Intel[®] Mobile Celeron[™] Processor at 466 MHz, 433 MHz, 400 MHz, 366 MHz, 333 MHz, 300 MHz, and 266 MHz Specification Update

Release Date: September 2000

Order Number: 244444-018

The Intel[®] Mobile Celeron[™] processor at 466 MHz, 433 MHz, 400 MHz, 366 MHz, 333 MHz, 300 MHz, and 266 MHz may contain design defects or errors known as errata which may cause the product to deviate from published specifications. Current characterized errata are documented in this Specification Update.

Figure 2. Workaround Flowchart: SMBALERT#-Driven System

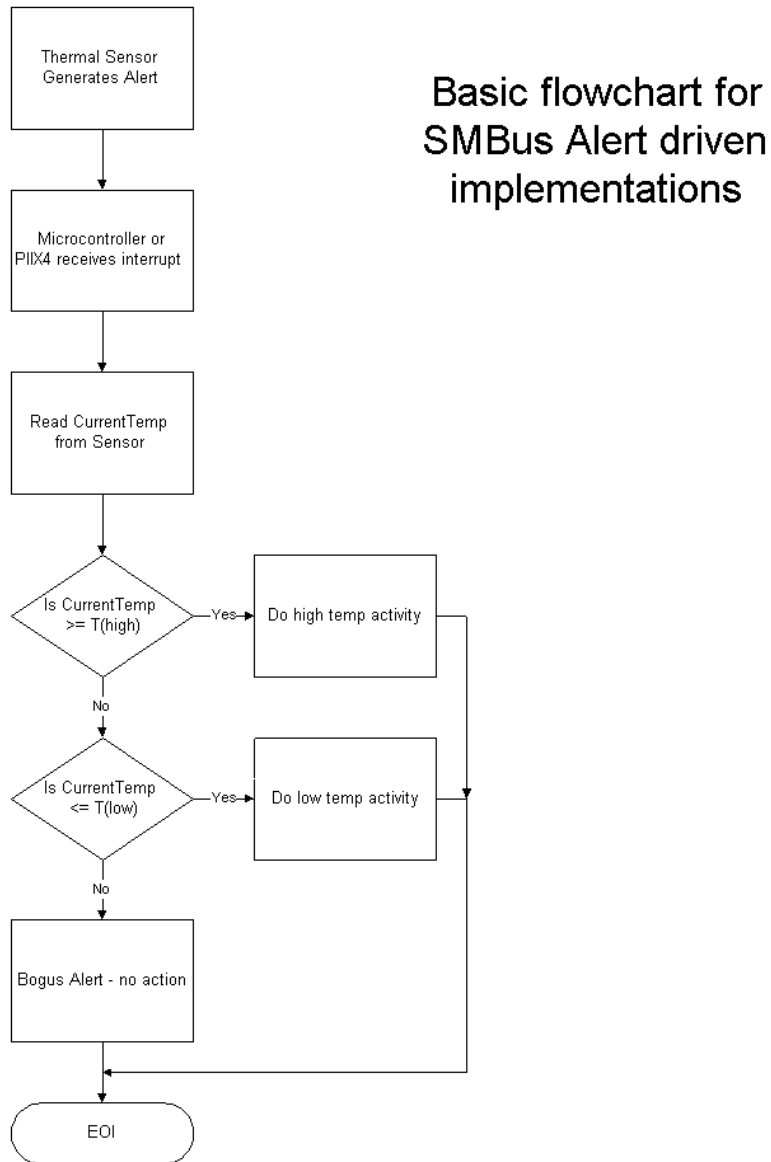
Workaround: Three different (mutually exclusive) workarounds are possible:

1. Before servicing an interrupt from the thermal sensor, read and compare the processor thermal reading with the threshold limits (T_{HIGH} or T_{LOW}). Figures 2 and 3 provide basic flowcharts for the implementation of this workaround in an interrupt driven system.
2. If the firmware implemented polls the Status Register only, then before taking any action, re-read the temperature register and do a comparison with the alarm threshold limits (T_{HIGH} or T_{LOW}) to determine if the value is actually still within the temperature window.
3. Use a temperature polling scheme to monitor the processor temperature.

Figure 5.3. Surface-Mount BGA1 Package—Top and Side View

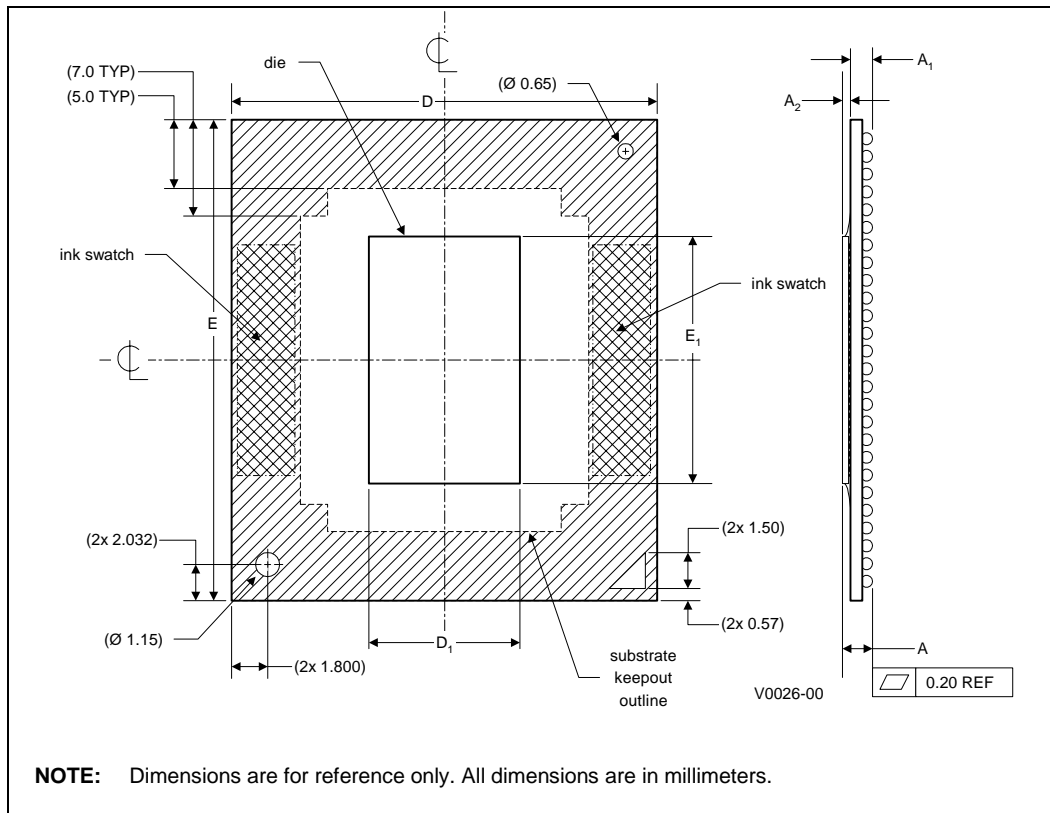
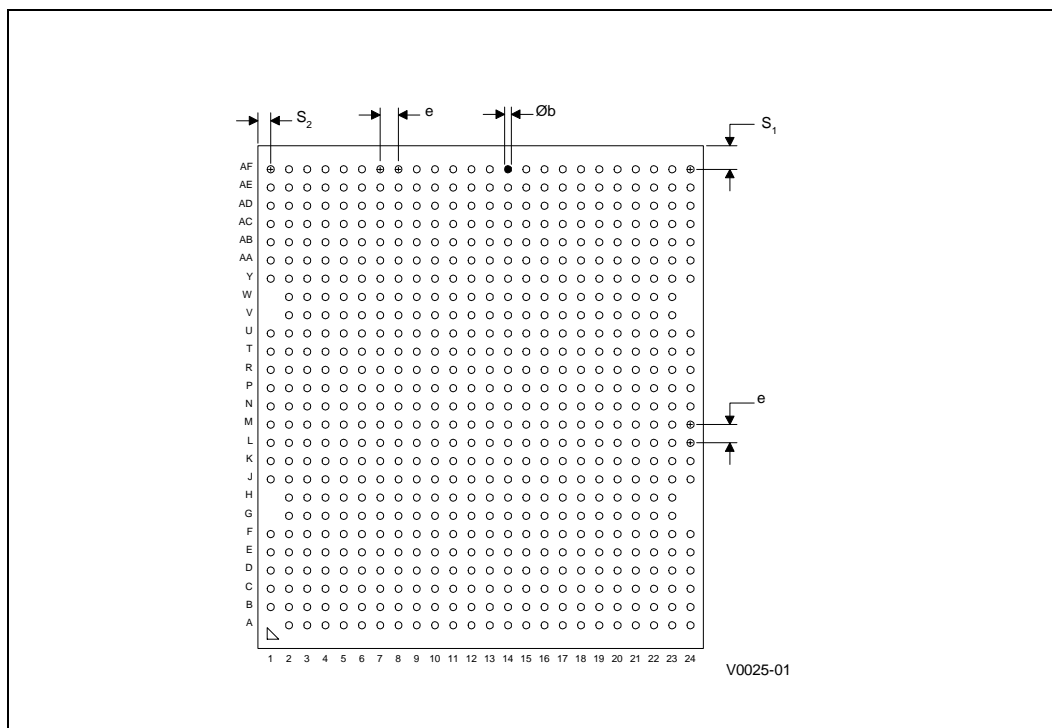
The following table and figures show the updated mechanical specifications for the BGA1 package, listed as Table 5.2, Figure 5.3 and 5.4, respectively, in the *Intel® Mobile Celeron™ Processor in BGA Package at 333 MHz, 300 MHz and 266 MHz* datasheet.

1. The number shown here is different from that in the 244444-004 version of this specification update. The maximum reference number is used.

Figure 3.3 Generic Clock Waveform

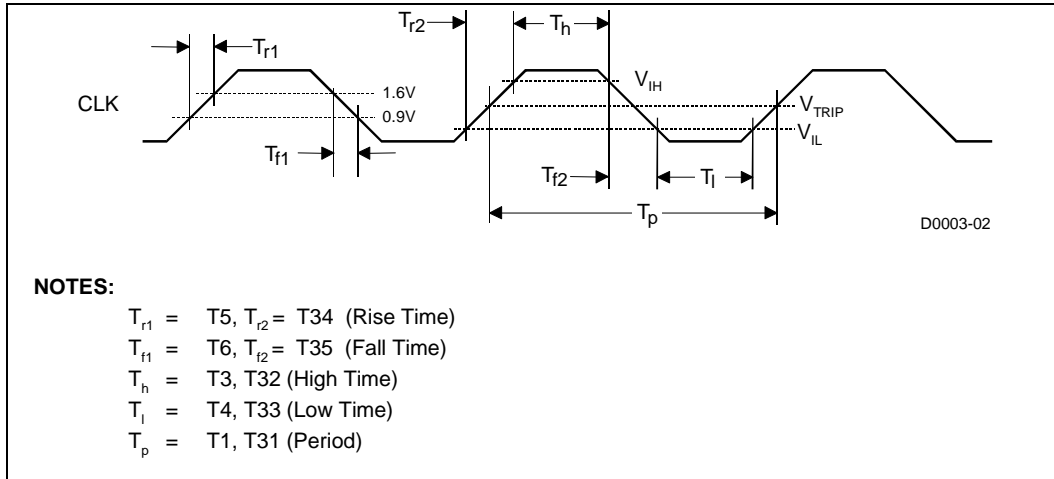
H11. Generic Clock Waveform Figure

Figure 3.3 in the *Intel® Mobile Celeron™ Processor in μPGA1 and BGA1 Packages at 366 MHz, 333 MHz, 300 MHz, and 266 MHz* datasheet (Order Number 245112-003) has been updated. The following figure is to replace the one in the above document.
